09/398,652 09/17/99 SAMARAS

Office Action Summary

6. Claims 19, 21, 23 and 26 are rejected under 35 U.S.C. 103(a) as being unpatentable over Gedney et al (US 5,483,421) in view of Beers (US 5,680,936).

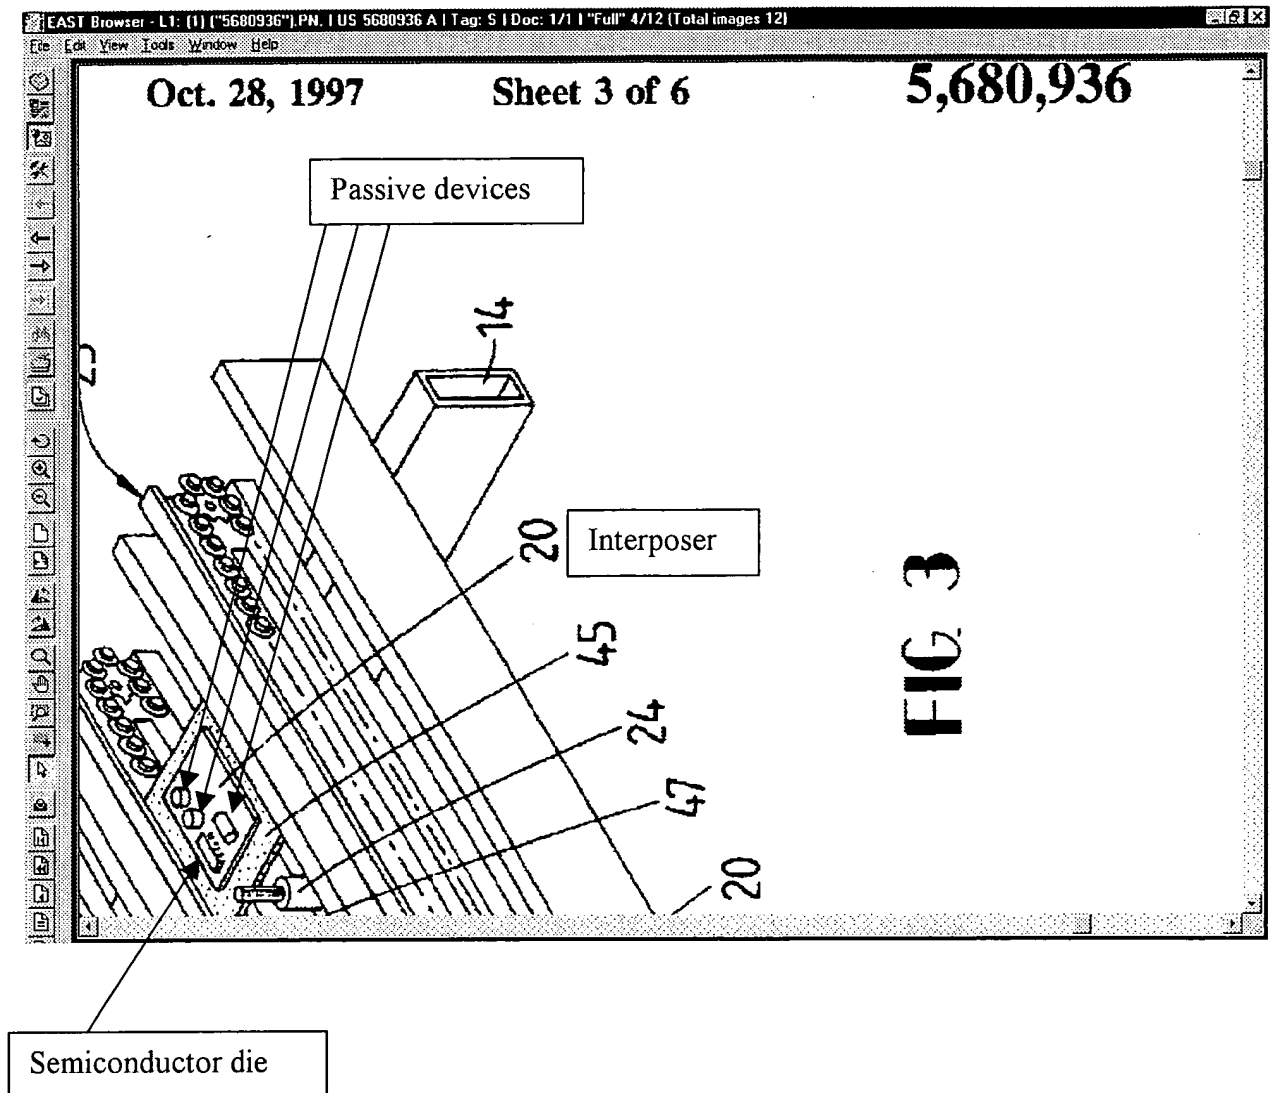
Beers discloses coupling at least one passive device (marked-up Fig. 3 below) to the first surface of the interposer (20) and testing the at least one semiconductor die (col. 7, lines 26-29 and col. 7, lines 46-48, discloses that the board or interposer 20 is tested. Therefore, the semiconductor chip and passive devices mounted on the interposer 20 are tested to determine whether they are "good" or "bad") thereby regulating voltage and current to the electronic chip and minimizing defective electronic components to increase customer satisfaction (col. 1, lines 36-43).

With respect to the Beers reference, Beers discloses coupling at least one passive device (marked-up Fig. 3 above) to the first surface of the interposer (20). Beers discloses testing the interposer 20 in col. 7, lines 26-29. Since the semiconductor chip and passive devices mounted on the interposer 20 are being tested, these components are tested along with the interposer 20. Further, in col. 7, lines 46-48 states that a tester T is capable of identifying the specific problem with an interposer 20, such as whether the semiconductor die is defective or not. With respect to applicants' argument that Beers does not couple the tested assembly to anything, Gedney teaches the coupling step in Paragraph No. 6 above.
